QUALITY ASSURANCE -- NON-CONFORMANCE REPORT

Reference Description: Missed UT indications by QC on Side Plate of Segment 8CW**Description of Non-Conformance:**

Job Name: SAS Superstructure

Subject: NCR No. ZPMC-0544

WELD NUMBER: SSD13A-PP065-128

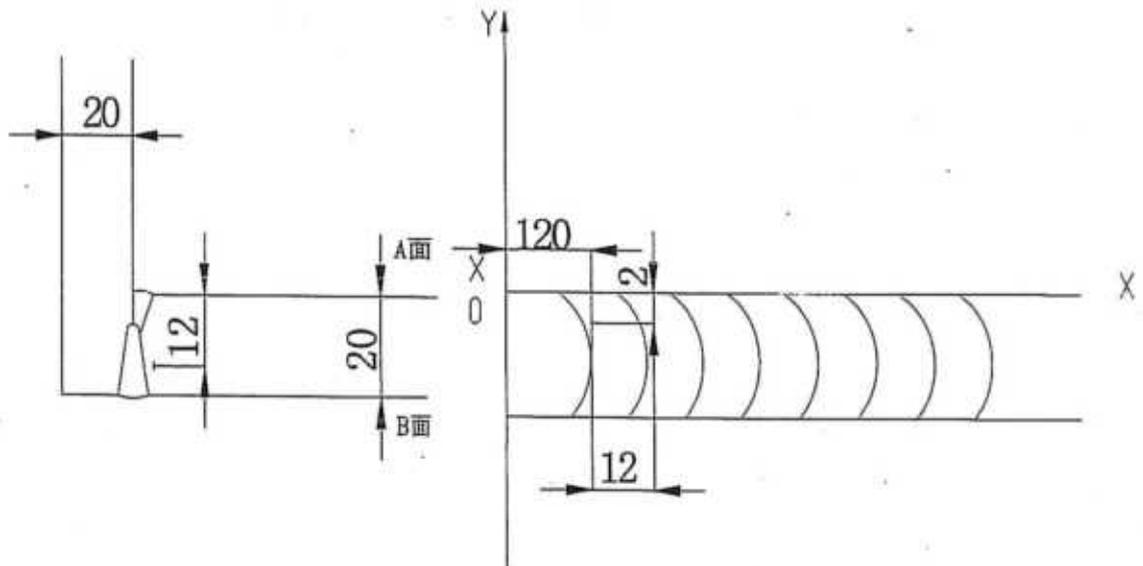
Description of welding discontinuity:

Rejected indication found by ultrasonic inspection is less than the maximum allowance aggregate length.

Caused:

1. Did not clear the weld pass completely in time.

Disposition :

1. Gouge or grind from nearer side from metal edge ($D \leq 0.65T$, "D" is depth of defects, "T" is thickness of metal) to remove all defects;

2. Follow repair WPS for joint preparation, preheat, and weld deposit;

3. Verify with VT no defects remain in the weld joint prior to welding;

4. Grind the repaired area flush with base metal or the adjacent weld;

5. Perform UT inspection to the weld along with 50mm on each end of the repair area;

WELD NUMBER: SEG048*-005

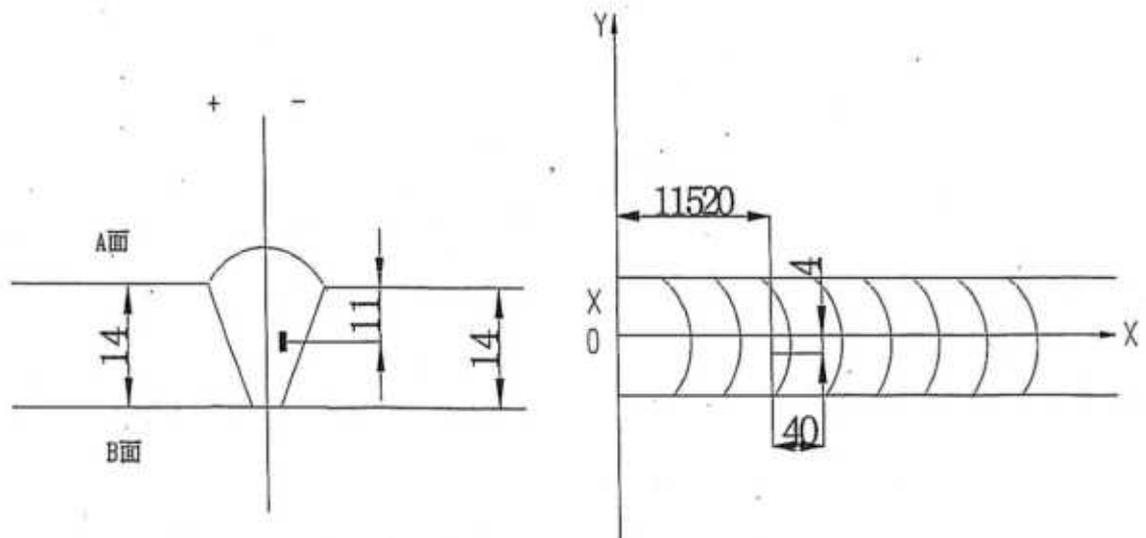
Description of welding discontinuity:

Rejected indication found by ultrasonic inspection is less than the maximum allowance aggregate length.

Caused:

1. Did not clear the weld pass completely in time.

Disposition:

1. Gouge or grind from nearer side from metal edge ($D \leq 0.65T$, "D" is depth of defects, "T" is thickness of metal) to remove all defects;

2. Follow repair WPS for joint preparation, preheat, and weld deposit;

3. Verify with VT no defects remain in the weld joint prior to welding;

4. Grind the repaired area flush with base metal or the adjacent weld;

5. Perform UT inspection to the weld along with 50mm on each end of the repair area;

(UT探伤发现的缺陷总长度小于最大允许长度。) CA053-003

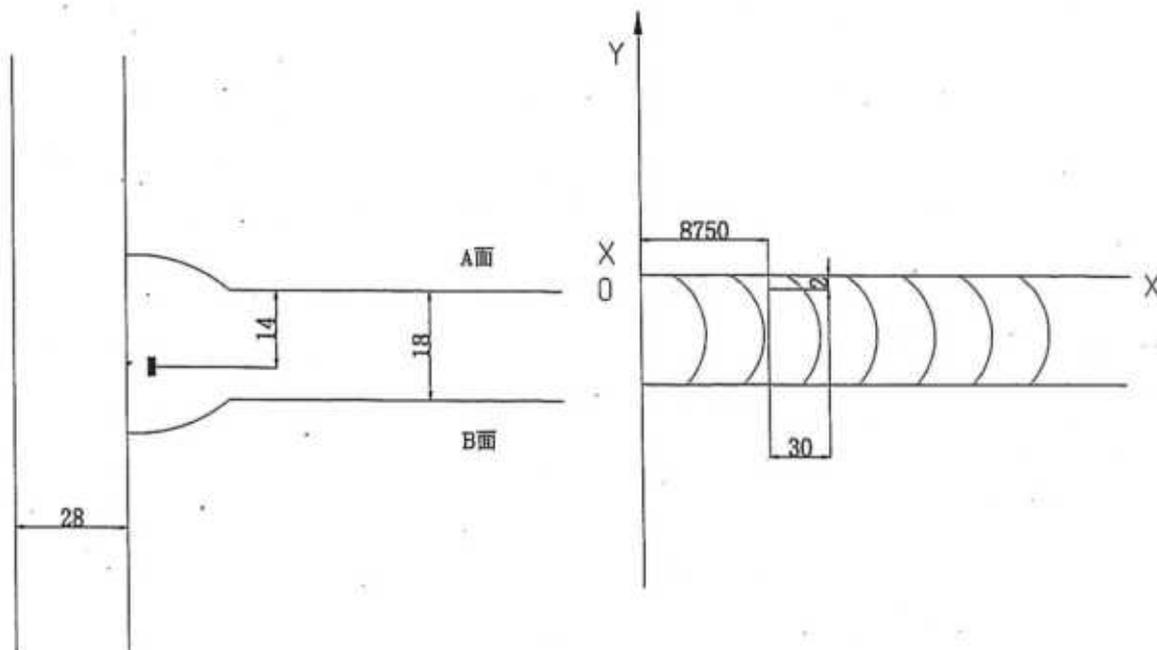
Description of welding discontinuity:

Rejected indication found by ultrasonic inspection is less than the maximum allowance aggregate length.

1. 从缺陷距离端面较近一侧 ($D \leq 0.65T$, D为缺陷深度, T为板厚) 采用碳刨或打磨的方法去除焊缝缺陷;
 2. 参照返修焊接工艺规程 (WPS) 准备正确的接头型式, 预热和焊接;
 3. 焊前对修补区域进行VT检测保证缺陷完全被消除;
 4. 将修补区域打磨到与母材或邻近焊缝平齐;
 5. 对焊缝进行UT检测, 检测范围为返修区域以及其两端各延长50mm.
-
1. Gouge or grind from nearer side from metal edge ($D \leq 0.65T$, "D" is depth of defects, "T" is thickness of metal) to remove all defects;
 2. Follow repair WPS for joint preparation, preheat, and weld deposit;
 3. Verify with VT no defects remain in the weld joint prior to welding;
 4. Grind the repaired area flush with base metal or the adjacent weld;
 5. Perform UT inspection to the weld along with 50mm on each end of the repair area;

(UT探伤发现的缺陷总长度小于最大允许长度。) SEG047B-012

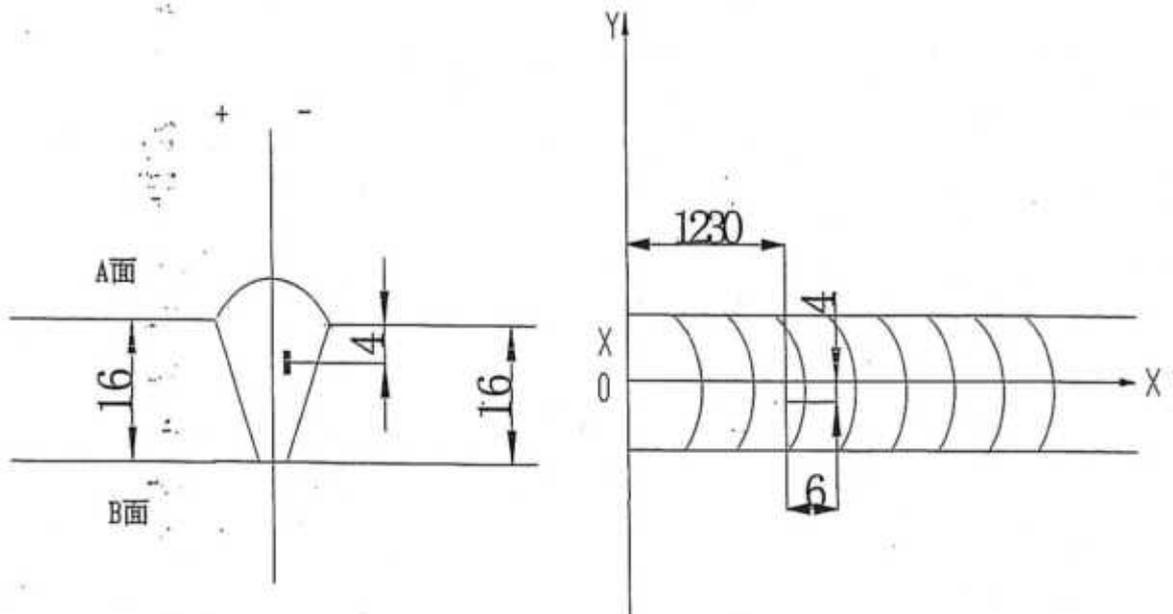
-Two (2) class "A" longitudinal linear indications measuring approximately 6mm and 10mm in length. Indication #1 is located in weld identified as SEG047B-012.

-The indication dBs rating is a +10.

-Material thickness is 16mm.

-The depth of the indication is approximately 4mm.

-The weld is a Complete Joint Penetration (CJP) butt joint joining Side Plate SP767A (SPCM) to SP727A (SPCM).

Description of welding discontinuity:

Rejected indication found by ultrasonic inspection is less than the maximum allowance aggregate length.

1. Gouge or grind from nearer side from metal edge ($D \leq 0.65T$, "D" is depth of defects, "T" is thickness of metal) to remove all defects;

3. Verify with VT no defects remain in the weld joint prior to welding;

(UT探伤发现的缺陷总长度小于最大允许长度。) SEG047B-013

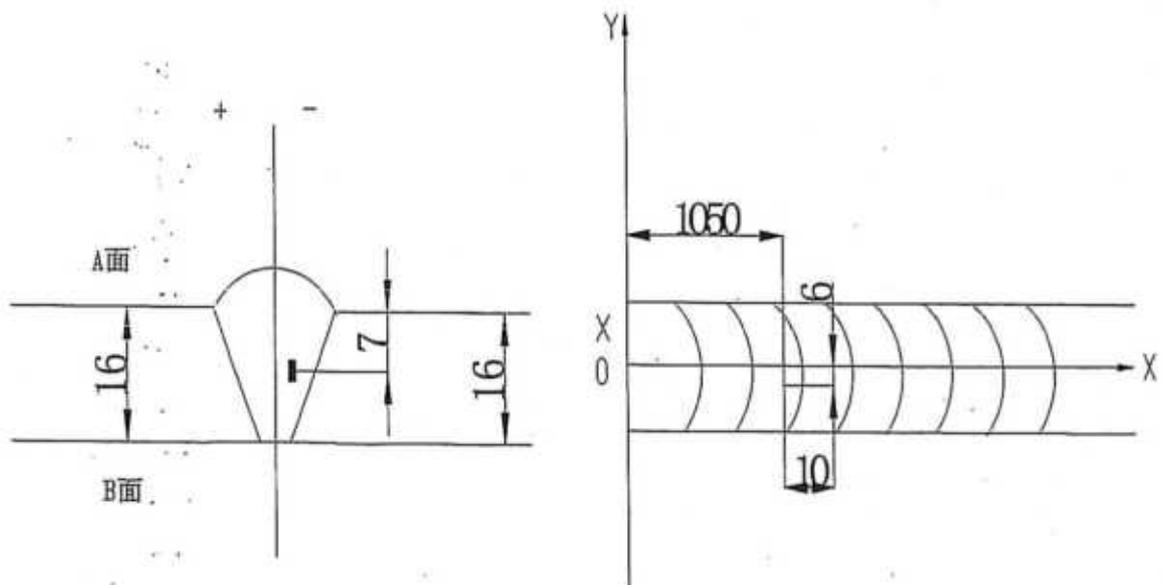
Indication #2 is located in weld identified as SEG047B-013.

-The indication dBs rating is a +9.

-Material thickness is 16mm.

-The depth of the indication is approximately 7mm.

-The weld is a Complete Joint Penetration (CJP) butt joint joining Side Plate SP727A (SPCM) to SP489A (SPCM).

Description of welding discontinuity:

Rejected indication found by ultrasonic inspection is less than the maximum allowance aggregate length.

1. Gouge or grind from nearer side from metal edge ($D \leq 0.65T$, "D" is depth of defects, "T" is thickness of metal) to remove all defects;

3. Verify with VT no defects remain in the weld joint prior to welding;
